E5515C-14B

E5515C Wireless Communications Test Set (8960 Series)

New design DSP board to replace failures on 8960 instruments upgraded to 5.8.

E5515-61301 – Existing 5.8 DSP Assembly with potential fault (note the integrated fan)

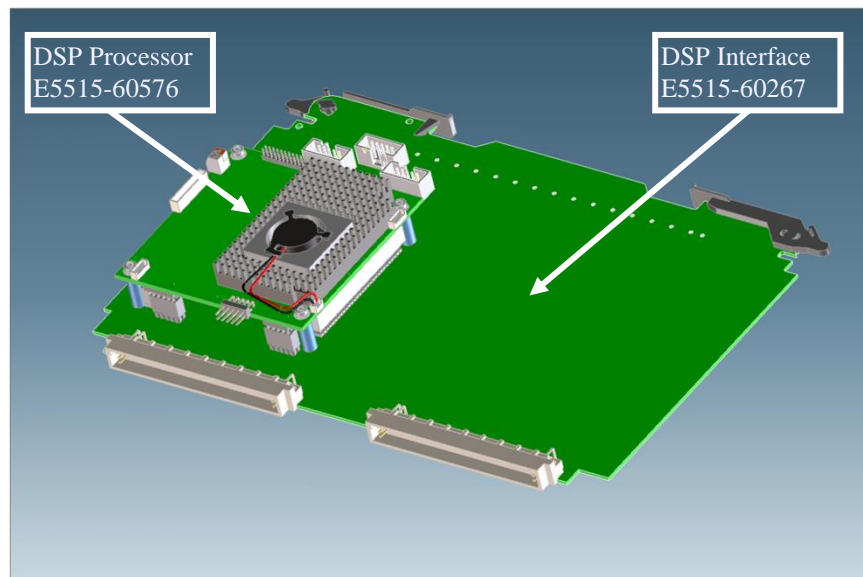
There has been an increase in failures on the E5515C due to the 5.8 version of DSP, assembly part number E5515-61301.

The DSP failure is due to a weak thermal design that, in some situations, can lead to a thermal stress failure most notably in year 2 and year 3 of life in high ambient temperature environments ie within test racks with little or no air conditioning.

At the time of failure, the whole DSP assembly should be swapped with a new DSP which has been designed for improved reliability.

At the same time, an additional fan should be added to the Power Supply to enhance the airflow across the DSP and further reduce the thermal stress.
